Delegated Report

Planning Application No: 20250570

Location: 5 Forge Lane Higham Rochester Kent

Description: Formation of frontage parking space and vehicle crossover.

Annotated (by the case officer) extract from drawing no. TAB/06/208A (not to scale)

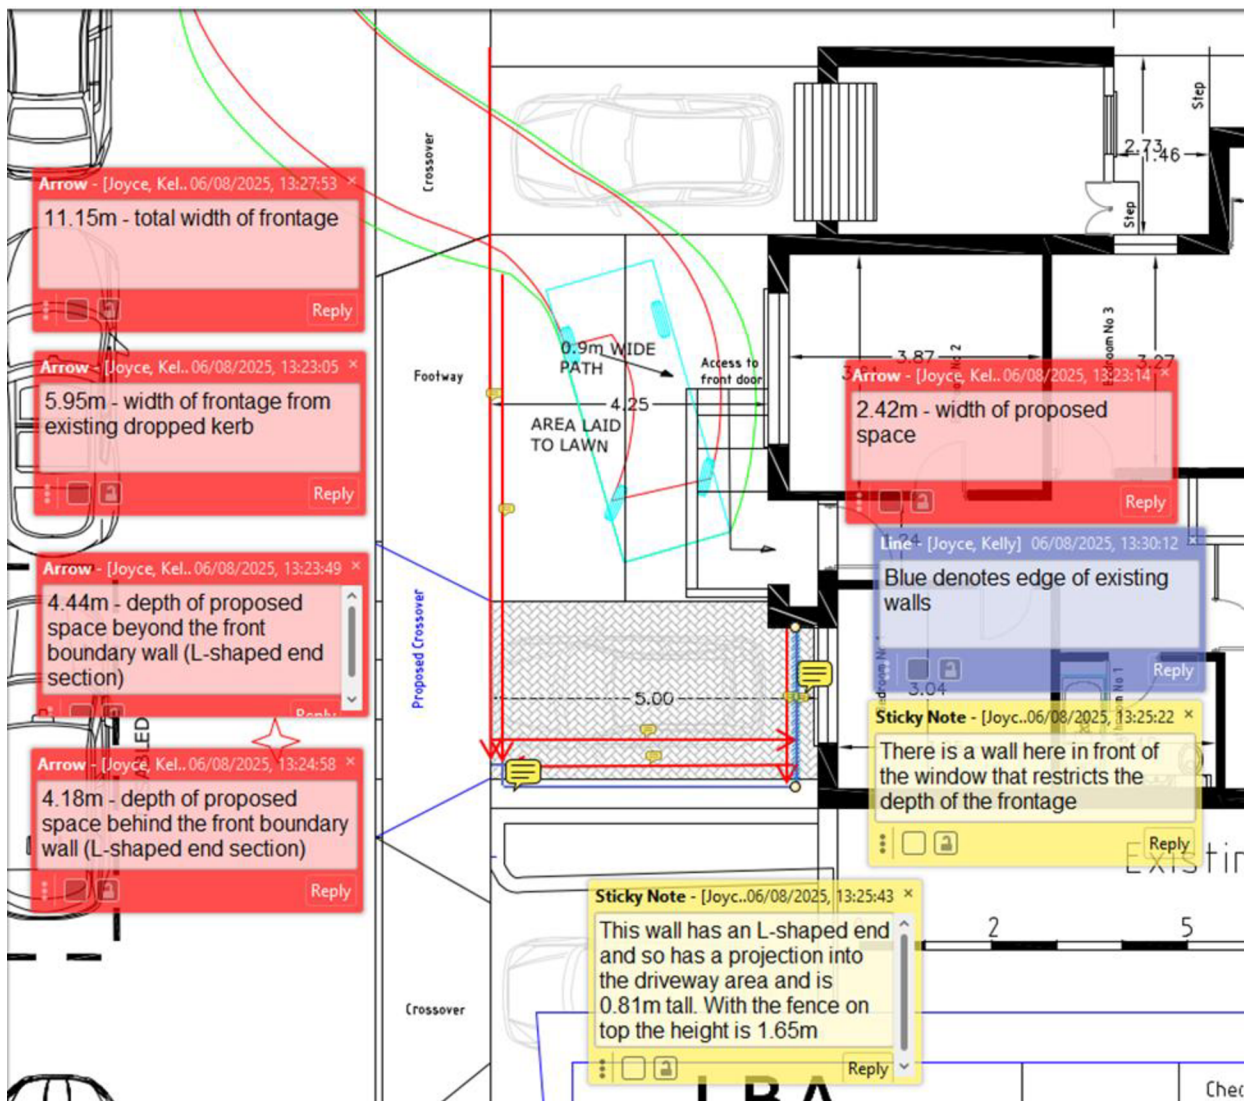
The submitted drawings do not show the site frontage accurately. An existing wall located on the side boundary with no. 7 Forge Lane (which has an L-shaped end that projects slightly across the frontage) is not illustrated nor is a wall located at the rear of the proposed parking space. The following images illustrate the existing walls (of red brick construction) and the dimensions measured at the site visit;

Whilst drawing no. TAB/06/209B illustrates a wall on the southern side of the application site, the accuracy of this drawing is questioned because it does not include the wall's L-shaped end, there is no wall at the rear of the parking space and also the depiction of the existing wall/access at no. 7 Forge Lane appears incorrect.

The following are images illustrating the proposed layout for the new access in application 20250079 and the current application;

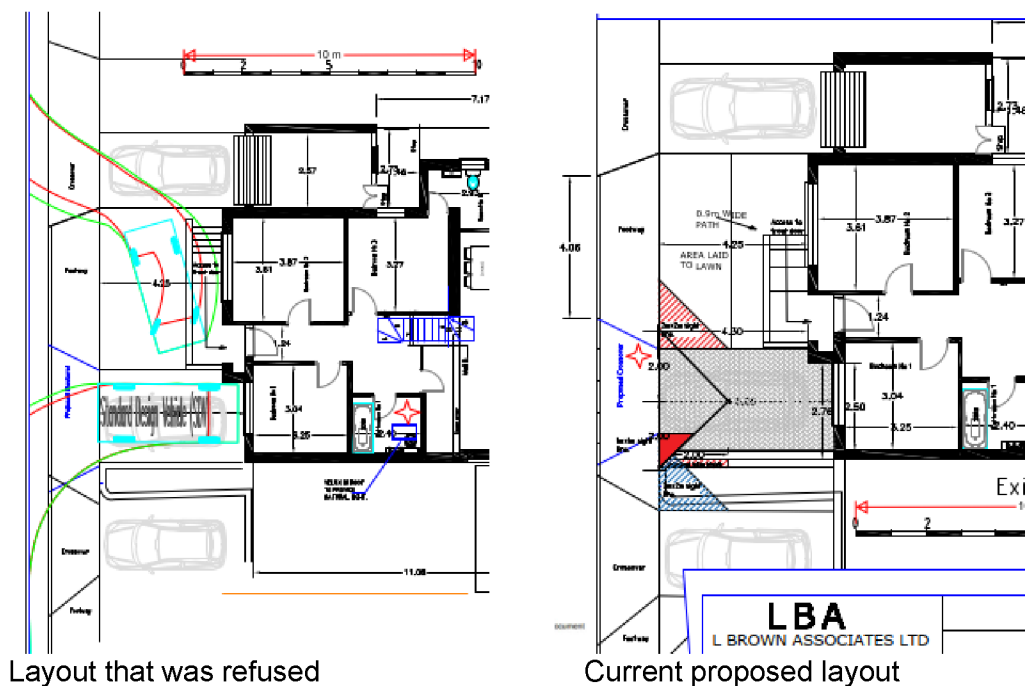
The refused proposal is very similar to the development that is the subject of the current application. The main alterations are that an area of the frontage would be laid to grass, the new parking area would be surfaced with porous block paving, the parking space would be slightly less wide and a wall on the southern side would be lowered in height.
